• 2014 DRC SUBMISSION – Proposed revisions to Tucson 2 project

LIST OF PROPOSED CHANGES

The Hub at Tucson II

CHANGES SUBMISSION. **PROPOSED**

Proposed East Elevation

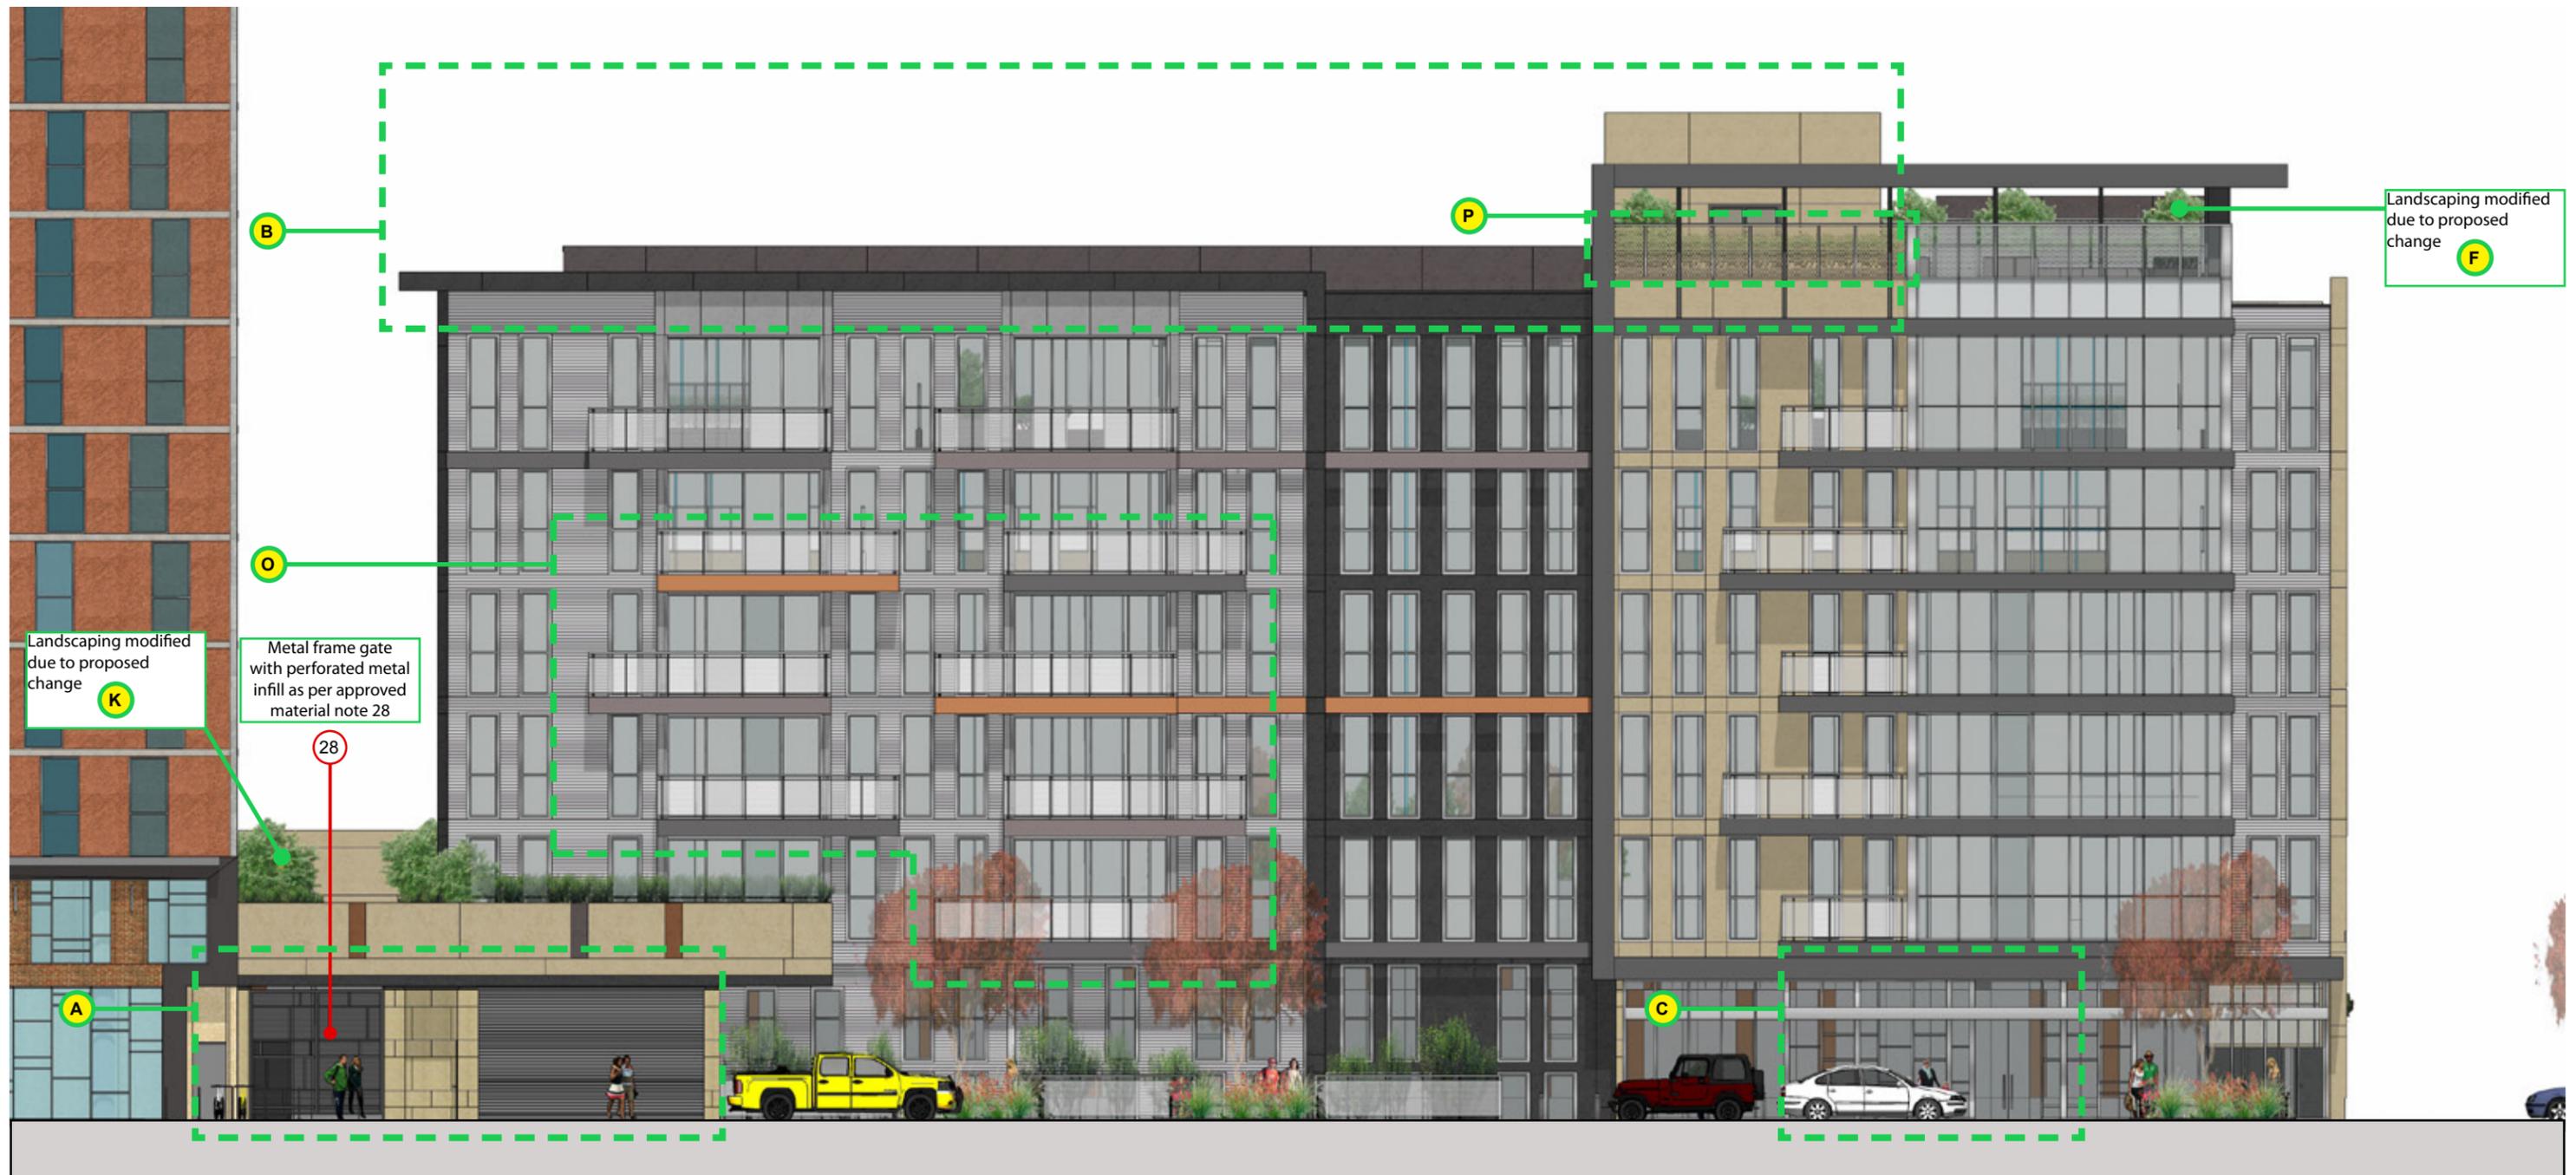
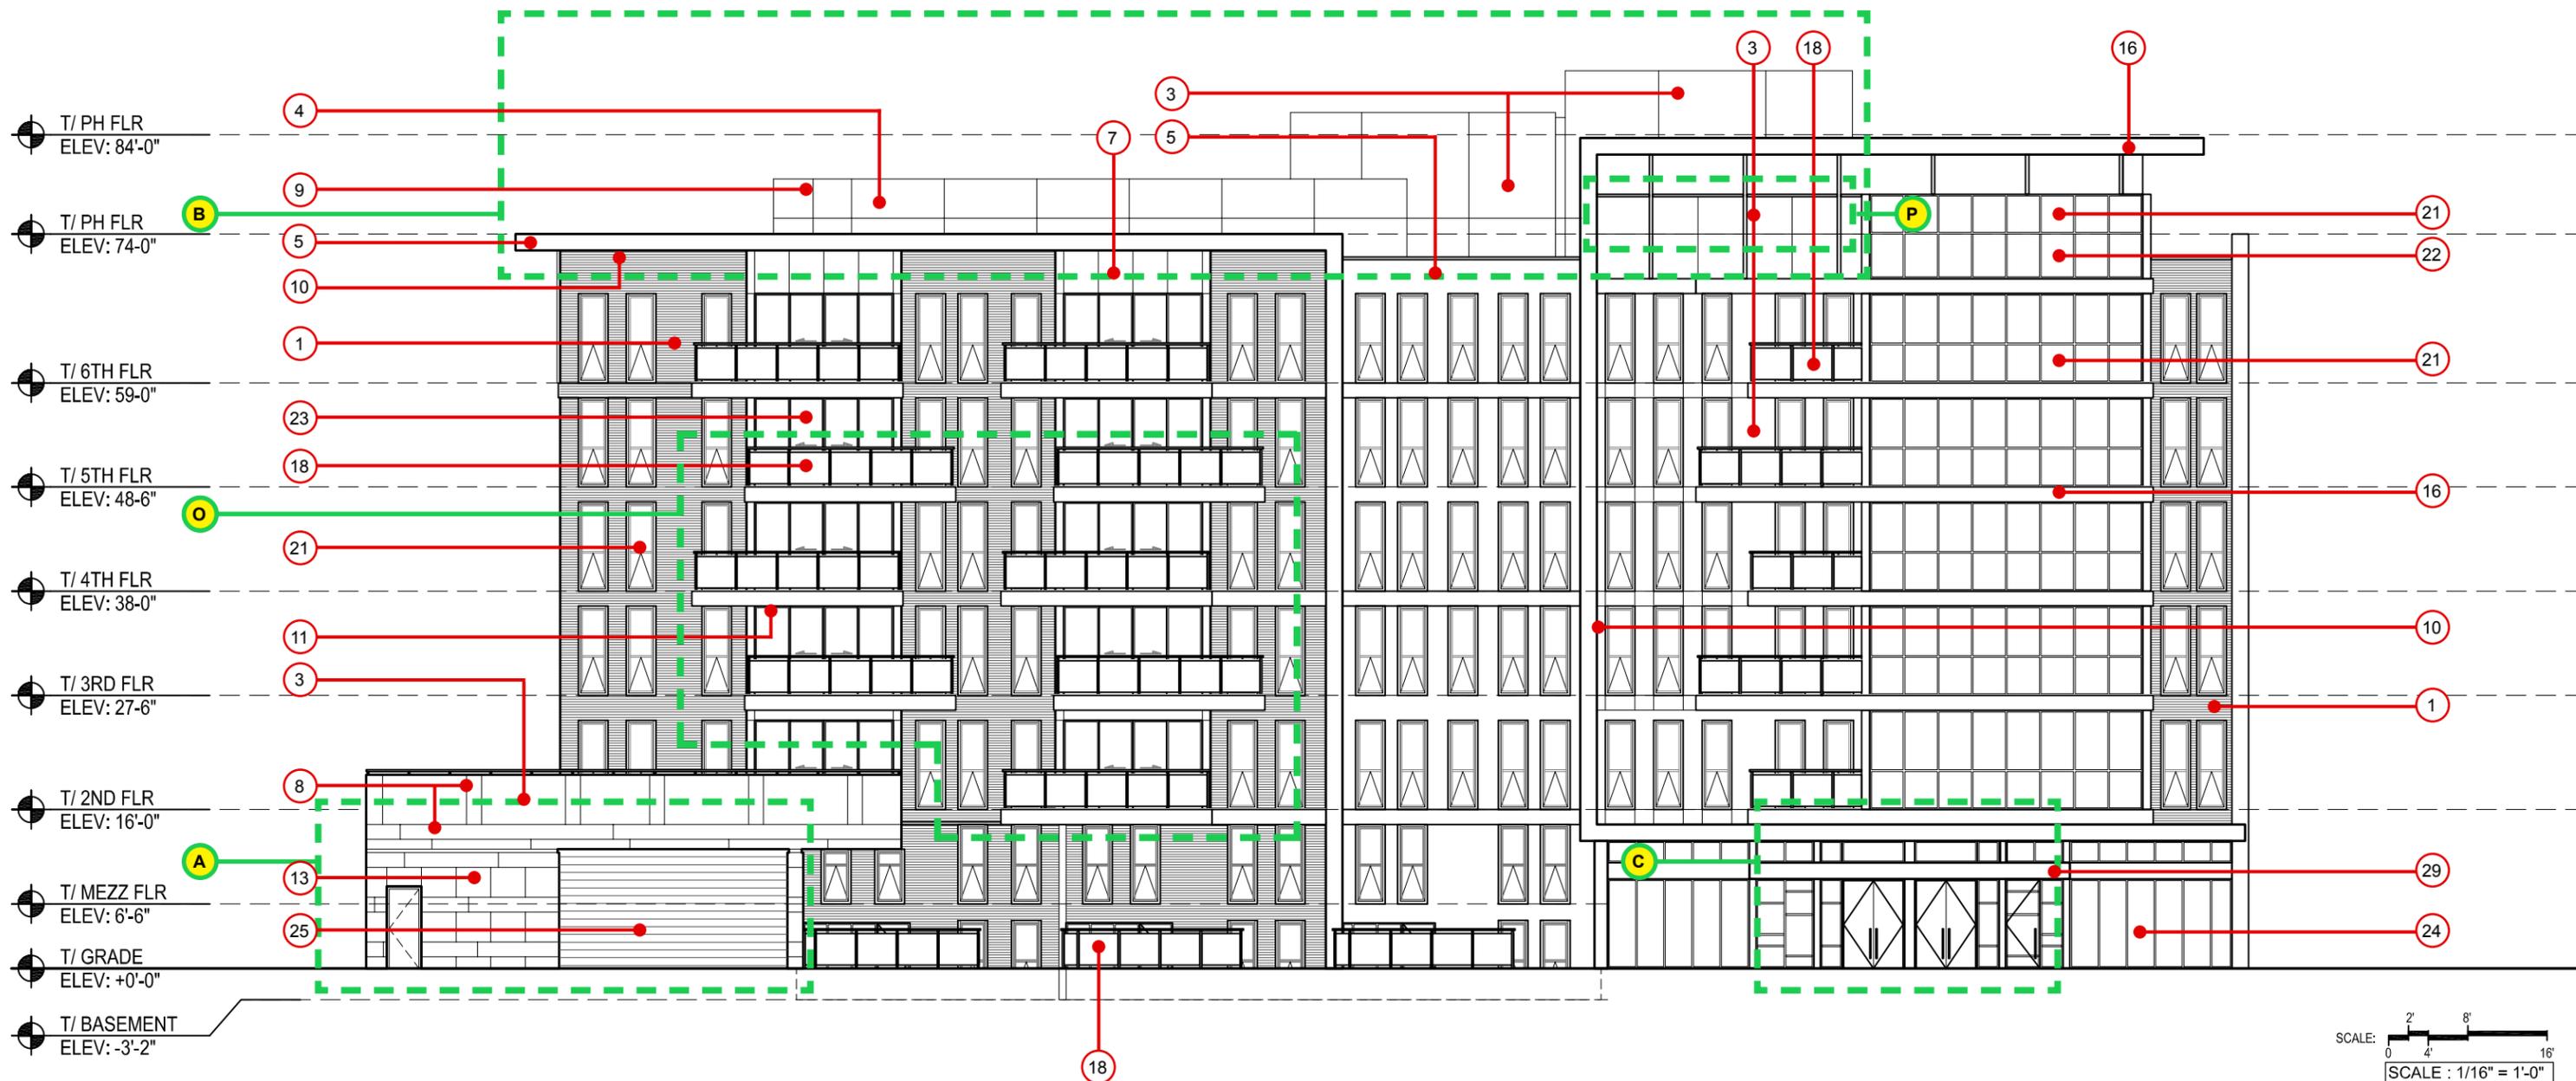
- **A** - Water meter enclosure and transformer room relocated from west alley to the Tyndall street facade. Garage door size reduced.
- **B** - Mechanical screen altered. Secondary screen removed and parapet height increase to 5' to act as screen, pool equipment room removed, elevator shaft footprint reduced and the elevator top of parapet height increased from 86' to 90' to allow for the mechanical lift overrun. 6th floor ceiling height increased by 1' with the south "I" eyebrow lifting by approx 1'10".
- **C** - Residential entry lobby and entry doors revised.
- **O** - Occupiable area of balconies reduced.
- **P** - Stucco cladding changed to perforated metal.
